Access Compliance Report

Public Rights-of-Way

Intersection ID: 6943	Main Street: BEATTIES_FORD_RD	Cross Street: CINDY_LN	Location: SE
ADA ID: CBF6551A4FB1	Ramp Type: PerpDiag	Initial Pass/Fail: Fail	Overall Compliance: No
Severity Score: 33.75			
Codes/Mitigation Info/Possible Solution		Field Measurements/Component Compliance

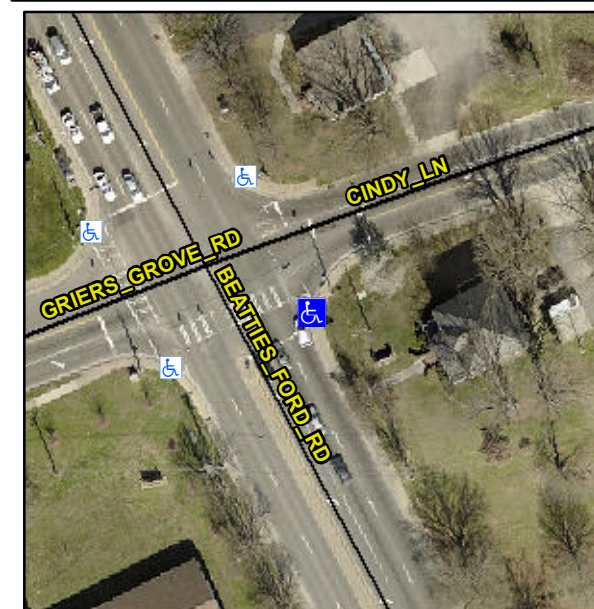
Not Found, R304.5.1, R304.2.2

Compliance	Description	Data	Compliance	Description	Data
N/A	Ramp Length (in)	58.0	No	Ramp Slope (%)	12.6
No	Ramp Width (in)	46.0	Yes	Ramp XSlope (%)	1.4
N/A	Flare Type LT	N/A	N/A	Flare Type RT	N/A
N/A	Flare Slope LT (%)	N/A	N/A	Flare Slope RT (%)	N/A
N/A	Flare Traversable LT?	N/A	N/A	Flare Traversable RT?	N/A
N/A	Landing Length (in)	N/A	N/A	DWS Provided?	N/A
N/A	Landing Width (in)	N/A	N/A	DWS Contrast?	N/A
N/A	Landing Slope (%)	N/A	N/A	DWS Length (in)	N/A
N/A	Landing X Slope (%)	N/A	N/A	DWS Full Width?	N/A
N/A	Landing Curb? (Y/N)	N/A	N/A	DWS Offset (in)	N/A
N/A	Shared Landing?	N/A			
N/A	Gutter Ponding?	N/A	N/A	Gutter Slope (%)	N/A
N/A	Gutter Lip Ht (in)	N/A	N/A	Gutter X Slope (%)	N/A
N/A	Painted X Walk1?	Yes	N/A	Painted X Walk2?	Yes
	X Walk 1 Direction	To NW		X Walk 2 Direction	To W
N/A	X Walk 1 Width (in)	90.5	N/A	X Walk 2 Width (in)	114.0
	X Walk 1 Slope (%)	0.7		X Walk 2 Slope (%)	2.7
	X Walk 1 X Slope (%)	0.0		X Walk 2 X Slope (%)	0.3

Remove & Replace Curb Ramp With Two New Directional Ramps or Equivalent.
